# On Ramps & Off Ramps: Response to Mr. Younger's 1/10/2018 ICAPWG Presentation\*

Zachary T. Smith  
Manager, Capacity Market Design

ICAPWG

February 2, 2018  
Rensselaer, NY

## Response (continued)

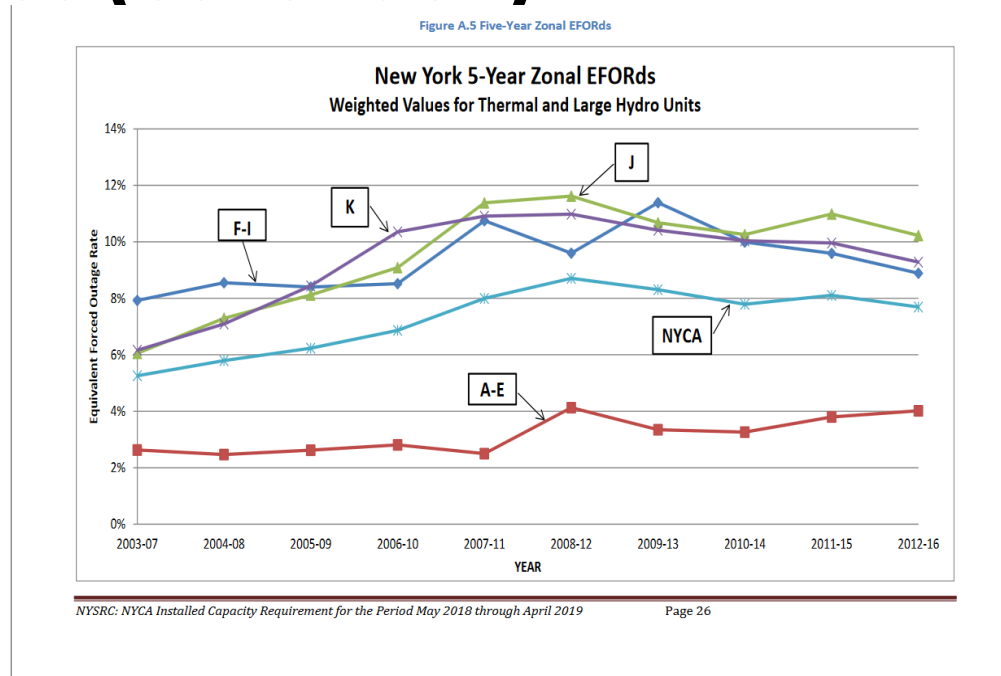
- Mr. Younger presented:
  - His concern: the modeling of generators would not align with the current capacity market requirement setting process or the proposed alternative LCR methodology
    - Specifically, intermittent generators are modeled at zero (0), traditional generators are modeled at ICAP, and SCRs are not modeled
  - His proposal: instead model all generators at UCAP and reduce Load Forecasts by SCR UCAP

- **Transmission Security Analysis with the additional 2G margin for creation is likely to send a “create” signal at least as soon as a Resource Adequacy Analysis**
  - NYISO views the Transmission Security Analysis with the additional 2G margin as sending an appropriate zone creation signal
- **Using a UCAP measure for generation and performing a Transmission Security Analysis would be the equivalent of increasing the create and eliminate margin from 2G/4G to some larger value (e.g., 3G/5G)**
  - 2G and 4G were selected as a proxy for a single plant and 2 plants
